Date April 20, 2023
To Town of Cumberland Planning Board
From Carla Nixon, Town Planner
Subject **Site Plan Amendment – Solar Field Installation - LGC - 221 US Route 1**

5. TOWN ENGINEER'S REVIEW: Dan Diffin, P.E., Sevee and Maher Engineers.

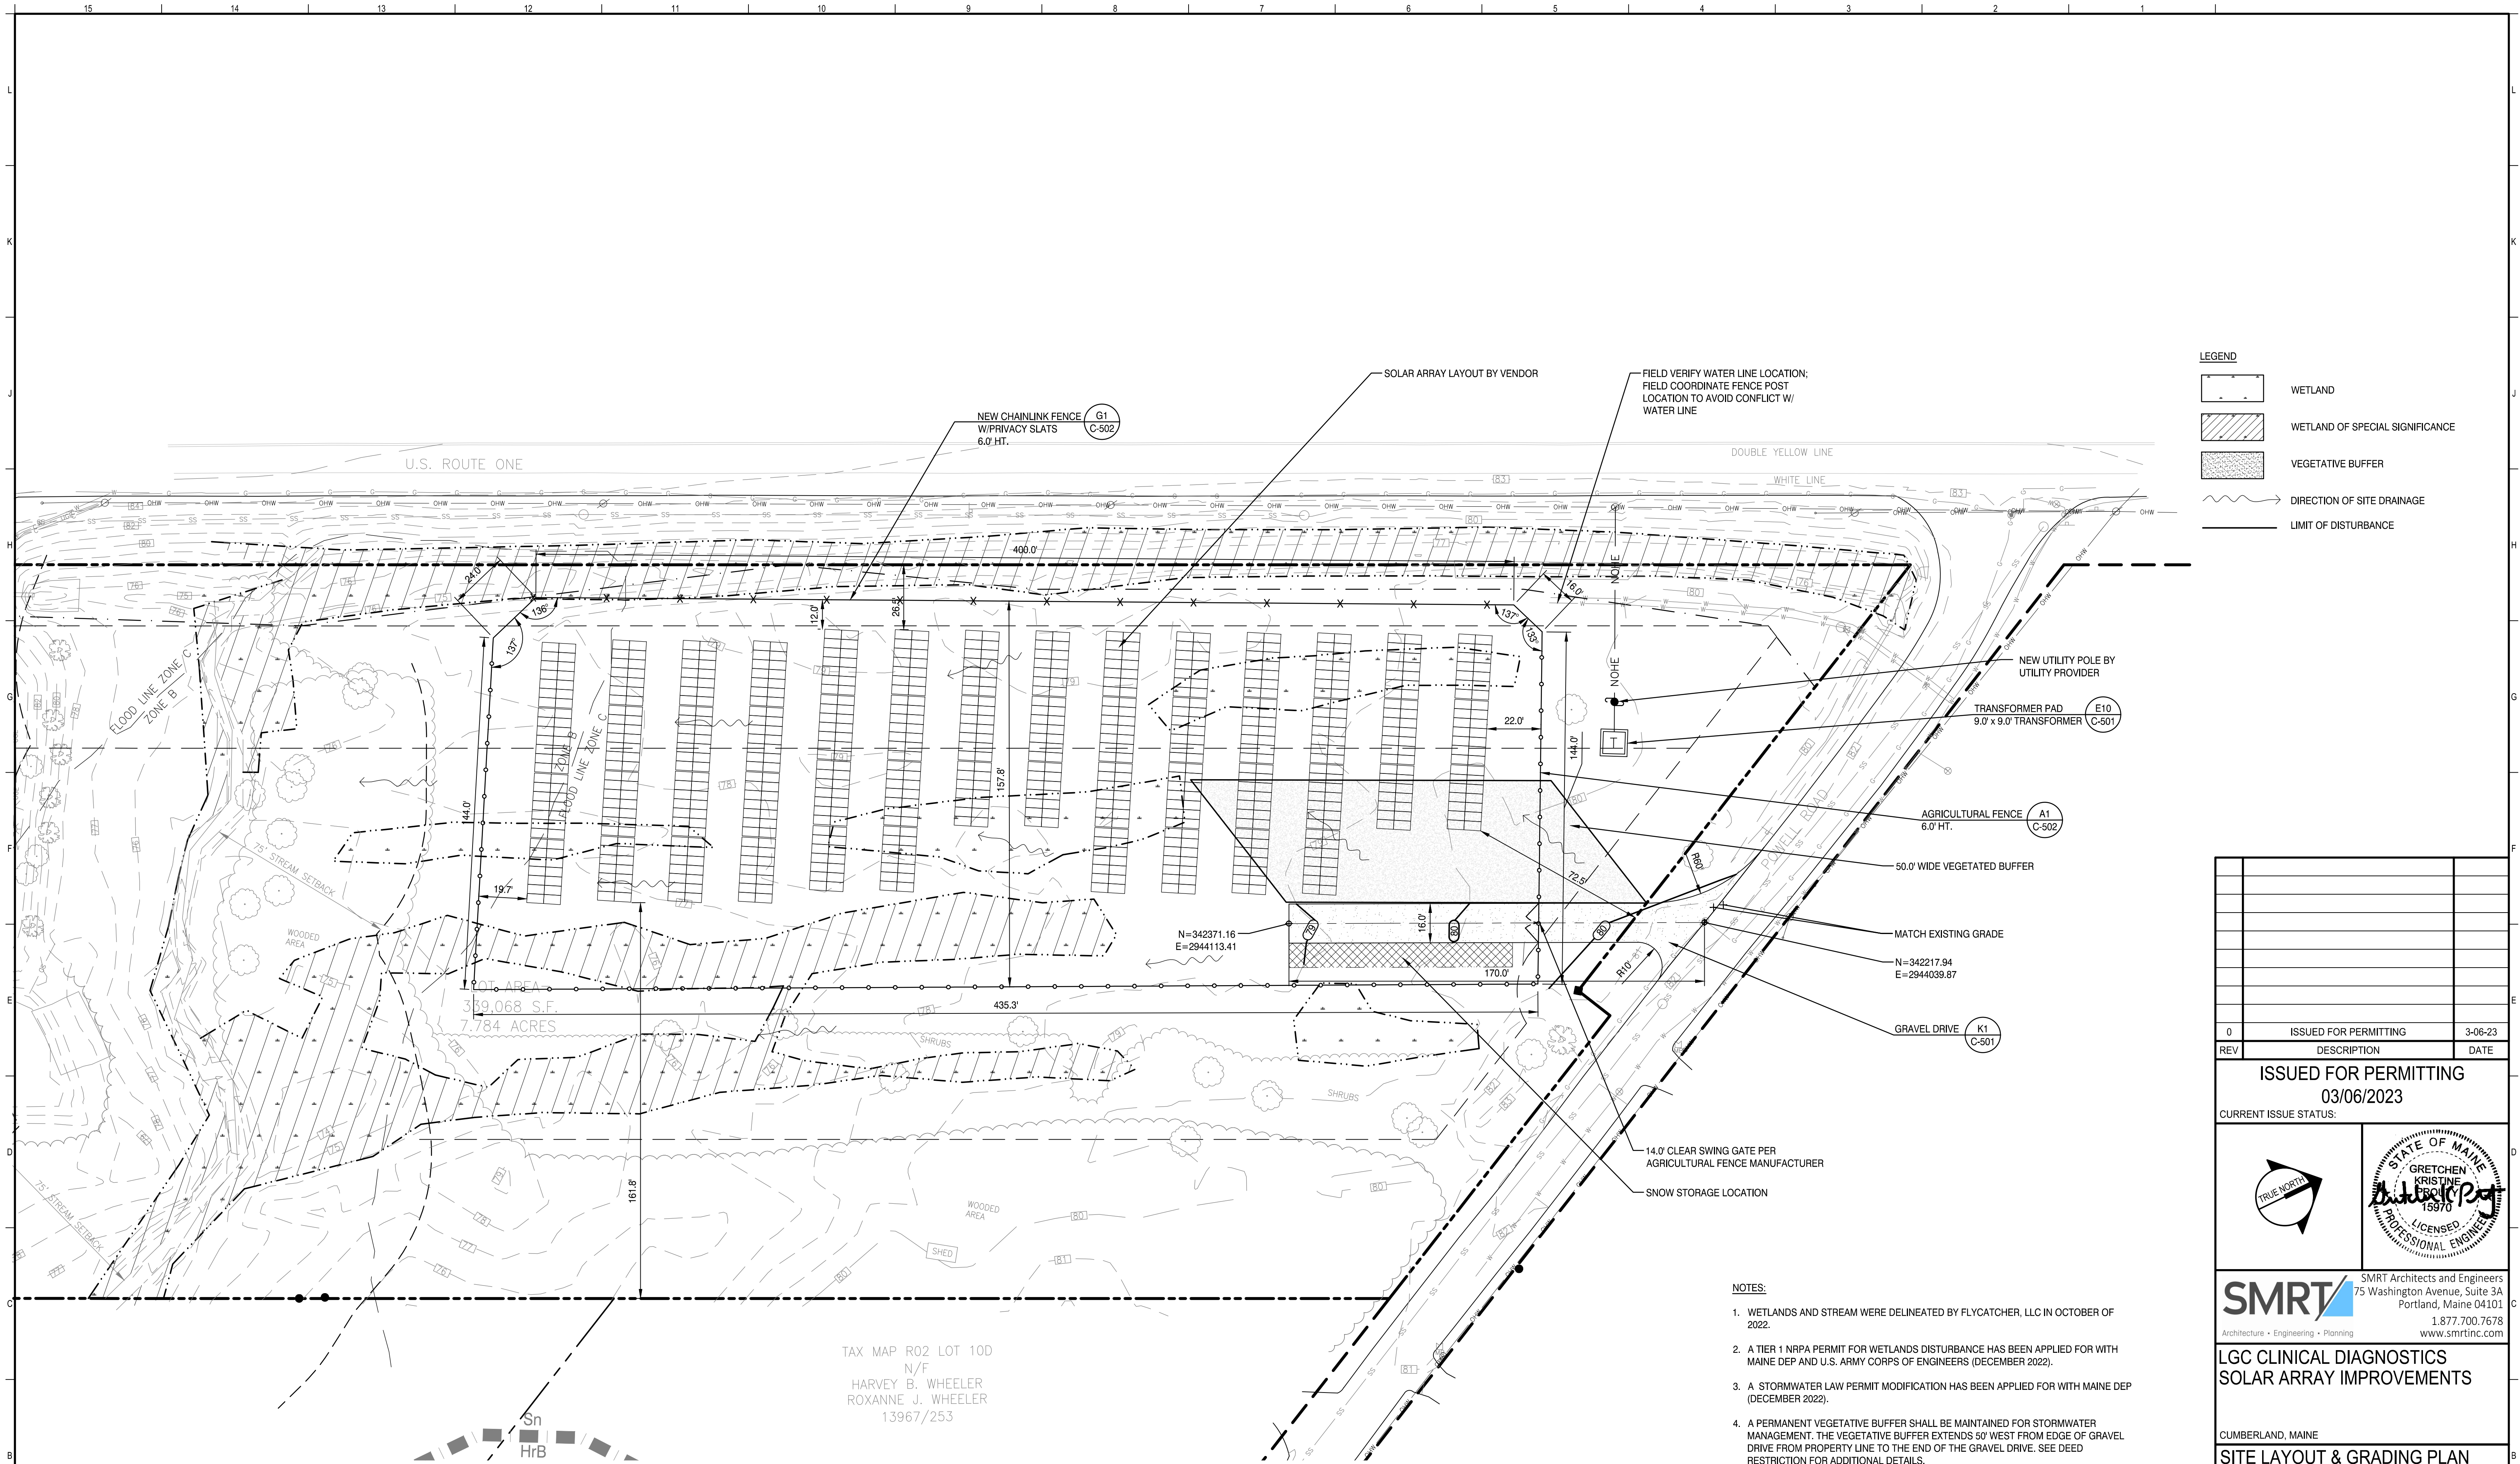
2. Site Layout & Grading Plan – Sheet C-102:
 - a. The grading of the access road appears to include two 80-foot contours on the proposed access drive. Please confirm grading to provide positive slope and drainage across driveway.

Response: Gravel access drive can accommodate fire truck access. Plan of truck turning operations has been added to plan to confirm access. See sheet C-102.

POST BASE
NOT TO SCALE (G7)

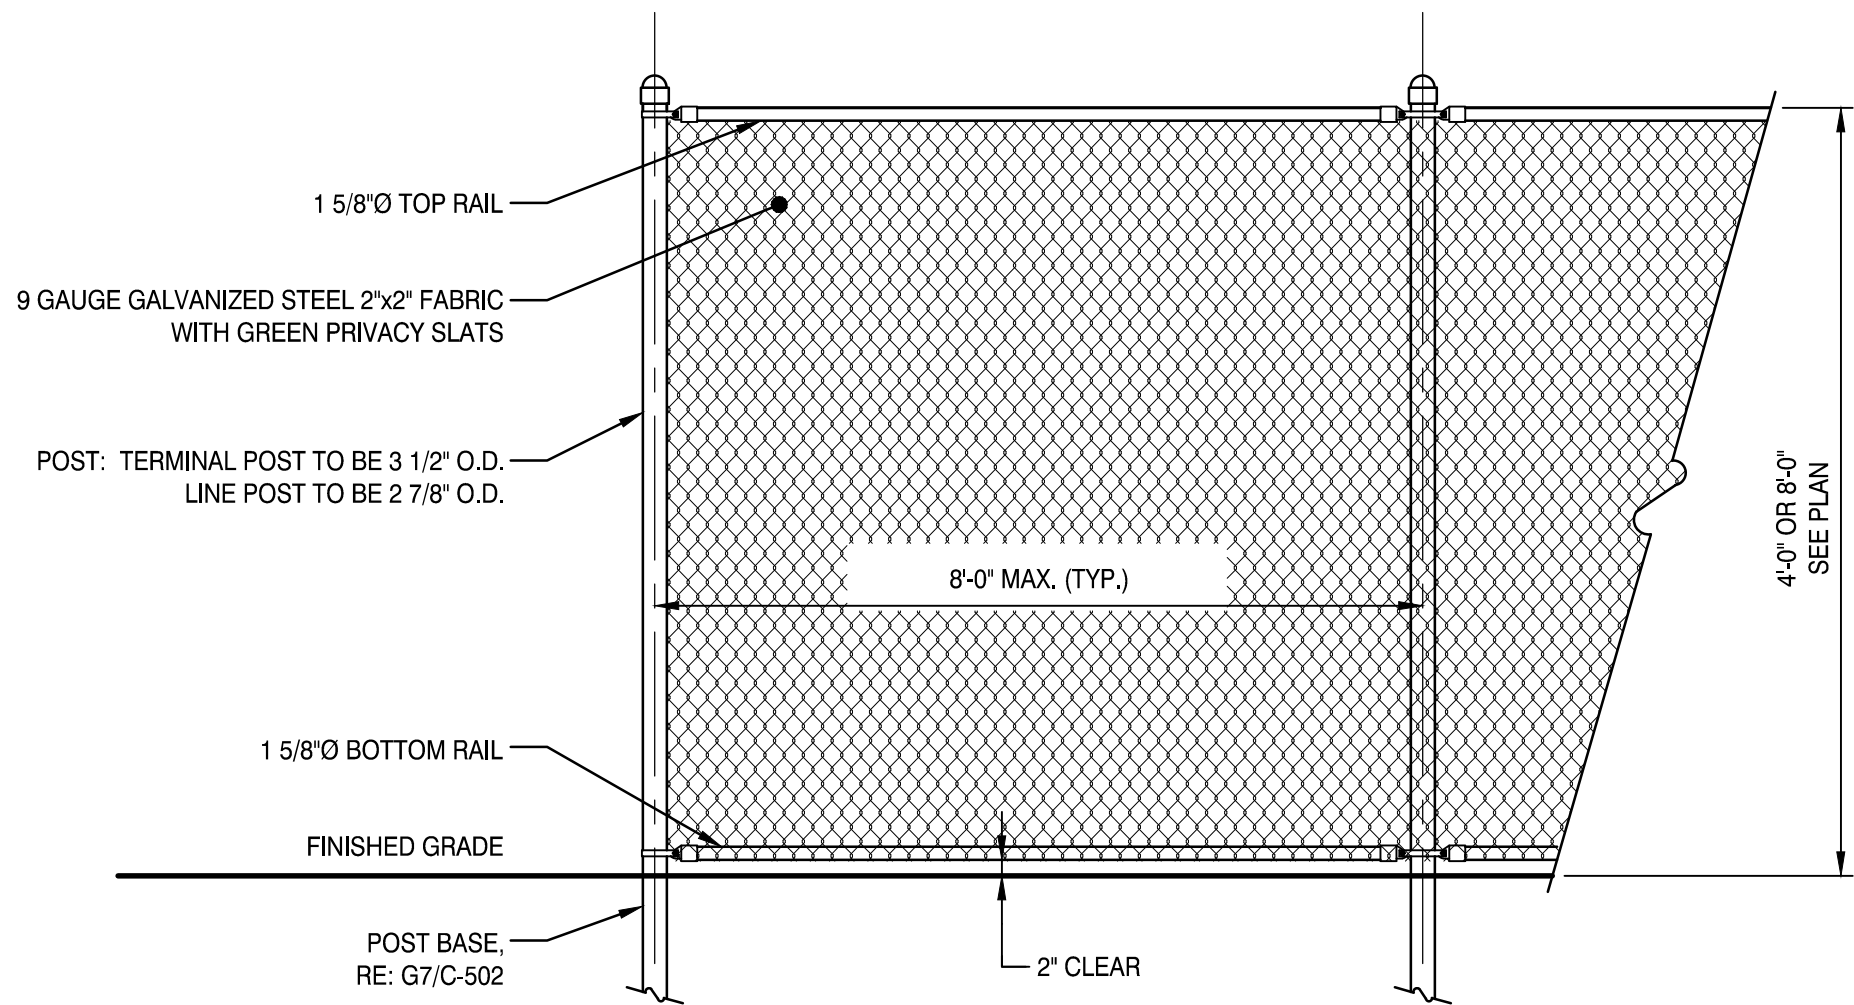
3. Site Details – Sheet C-502
 - a. The Post Base detail may not be deep enough for be below frost. SME recommends the Applicant confirm that the Post Base is below frost.

PLANTING PLAN (G1)
1" = 20'

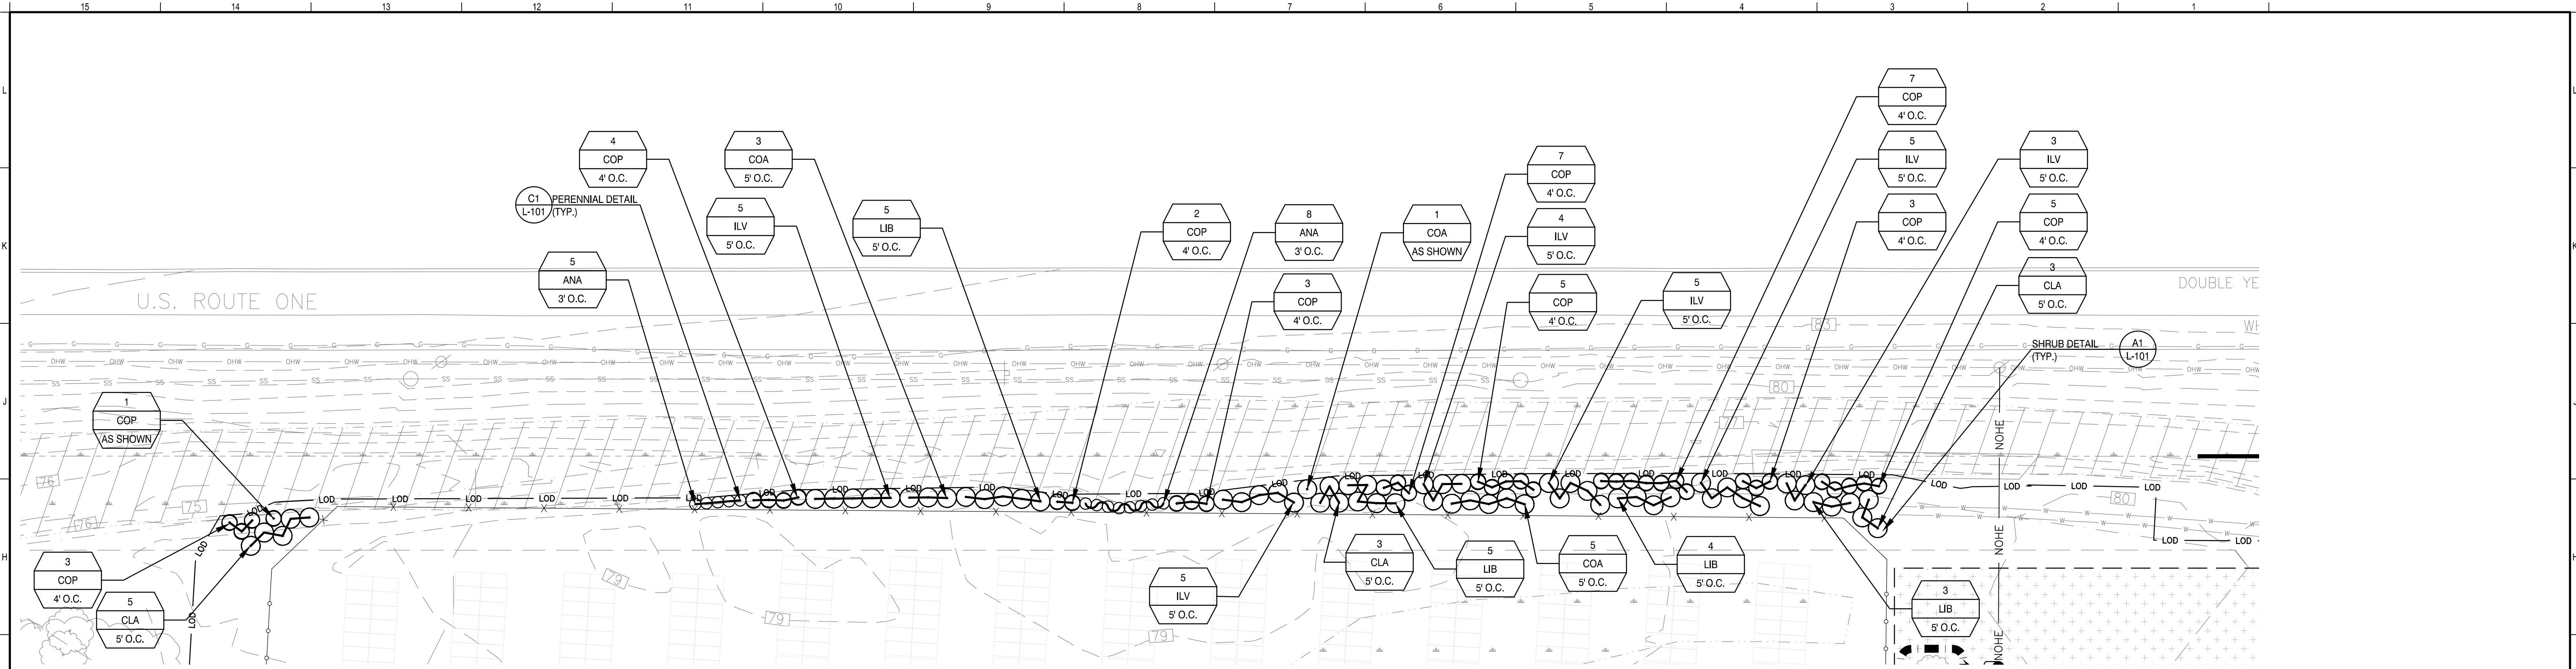
- a. US Route One Buffer - The panels are 6-feet tall and the chain link fence with privacy slats along US Route One is also proposed to be 6-feet tall. Since the site sits below the elevation of US Route One by approximately 4-feet, it is likely that the views from a car or pedestrian level will look over the top of the proposed fence and down into the array. Please confirm that the fence will fully screen the array, or that the plantings will grow to a height to screen the array.

- b. Powell Road Property – There is no screening of views along the Powell Road property line. The proposed agricultural fencing will not screen the array. Please provide additional information that demonstrates compliance with this section of the ordinance.
